N6731B-01

S E R V I C E N O T E

N6731B 50W DC Power Module

Current Measurement accuracy is out of specification when there is voltage being sourced at the output terminals.

Location of C36 and C37

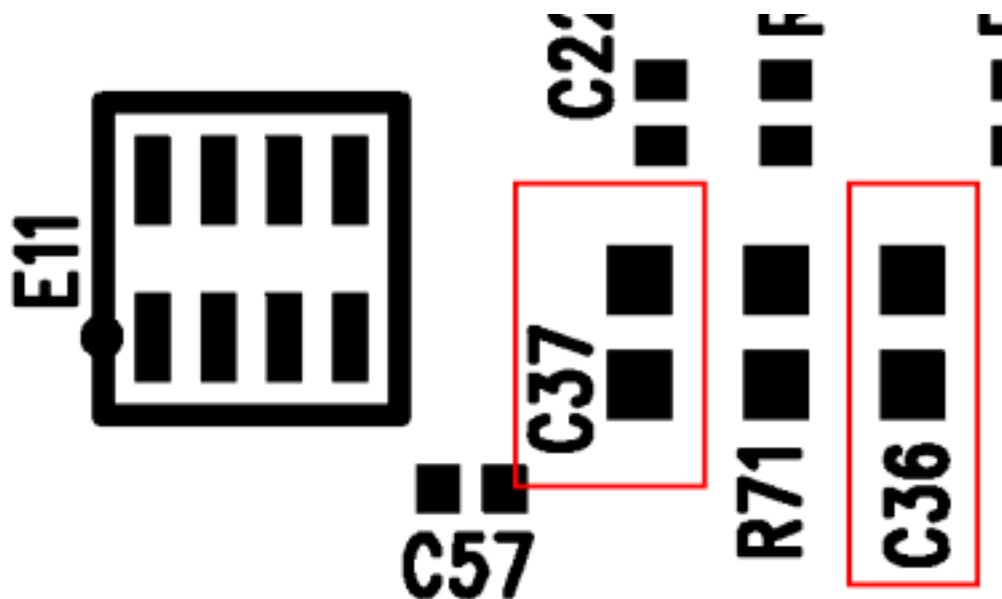
Due to some noise filtering issues, the current measurement accuracy will be out of specification by a fixed offset when there is a voltage being sourced at the output terminals. If the output is shorted, the current measurement accuracy will be within specifications. Please note that the performance verification test will not catch this.

If this measurement is out of specification, replace capacitors C36 and C37 on the DPM assembly (this is the assembly that is vertically mounted in the unit that looks similar to a PC memory module) with part number 0160-7809. After the capacitors are changed, the unit will require re-calibration. After the capacitors are replaced, check the make sure that the unit is in specification by applying 75% of the full voltage range while attached to a load drawing 50 mA to 70 mA. If the current measurement is within the specification, then the unit has been repaired.
